Alaska Railroad Corporation
327 W. Ship Creek Ave.
Anchorage, AK 99501

Addendum 2
Invitation to Bid # 20-26-208267
Whittier Yard: Subgrade Drainage Improvements

Addendum number 2 is issued for additional Questions

Fabricated Manhole Adapter with A-Lok or KOR-N-SEAL Gasket

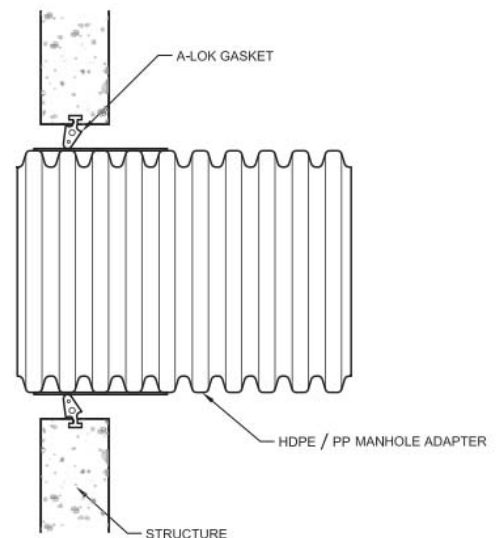
6. Will ARRC entertain the use of HDPE pipe?
- a. Yes if the use of Smooth Wall HDPE plastic pipe (HDPE) is elected, the Contractor will be asked to provide an adjustment in price from the aluminized steel pipe. See the updated bid schedule. Pre-cast structures receiving HDPE pipe must be fitted or retrofitted with a fabricated manhole adapter with a KOR-N-SEAL, or equivalent, gasket.

Wall thicknesses of substituted pipe are as follows: 12"Ø pipe – SDR 7 max., 18"Ø pipe – SDR 9 max., and 24"Ø pipe – SDR 13.5 max.. The minimum cell classification for the polyethylene plastic shall apply to each of the seven primary properties of the cell classification limits in accordance with ASTM D3350, minimum cell class 335434C. Pipe shall be produced from HDPE certified by the resin producer meeting the requirement of ASTM D3350. Pipe shall be joined using the butt fusion method as recommended by the pipe manufacturer, for both equipment and technique. The use of electrofusion couplers is acceptable if the Contractor elects to do so and there use does not affect the flow within the pipe. Fusion operations must be performed by an individual who has demonstrated the ability to fuse polyethylene pipe in the manner recommended by the pipe supplier. For the placement of HDPE, each

section is to be thoroughly inspected prior to being placed within the trench. Defective or damaged pipe shall not be used. HDPE shall be protected from exposure to direct sunlight prior to laying. Compaction of the bedded trench floor and the pipe haunches is paramount to the successful installation of the HDPE. Pipe shall not be laid within in trenches that have standing water within them or when the trench conditions or weather are unsuitable for such work. Pipe lengths shall be adjusted to accommodate for expansion and contraction in accordance with the following:
